Deadline 8: Responses to REP7-052 (EN010012-007054- Responses to ExQ2) and REP7-059 (Comments at Deadline 7 on Submissions from earlier deadlines and subsequent written submissions).

This paper is a response to the Applicant's replies to enquiries made by the Planning Inspectorate relating to my documents.

Author: Nick Scarr IP 20025524

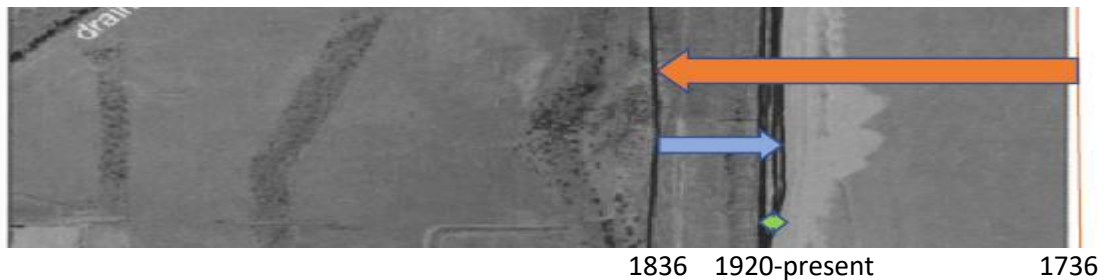
My response: I have not found evidence that the major episodes in coastal change listed below have been fully evaluated in the DCO documentation:

- 1 Erosion 1736-1836:** The Sizewell shoreline between 1736 and 1836 is the ‘**most eroded shoreline on record**’ according to EDF in BEEMS TR058. It appears that the 1836 shoreline had eroded approximately 300m in one century to just 20m seaward of the present-day Sizewell B. The orange arrow represents this period. See section 2.
- 2 Accretion 1836-1920: The Sizewell-Dunwich bank grew after 1824 and protected the shoreline;** between 1836 and 1920 the Sizewell shoreline accreted 80-90m to roughly its present location. The present shoreline is therefore notably ‘soft and erodible’. See section 2. The blue arrow represents this period.
- 3 Stability 1920-2000: 1920- present day,** relative stability. The green double arrow represents this period. See section 2 for the full chart shown below.

In my opinion, no one episode is more important than another; all must be fully considered. The accretion period coincides with the development of the Dunwich bank. It is a reasonable statement to suggest this is vital evidence that the Dunwich bank is then critical to shoreline stability.
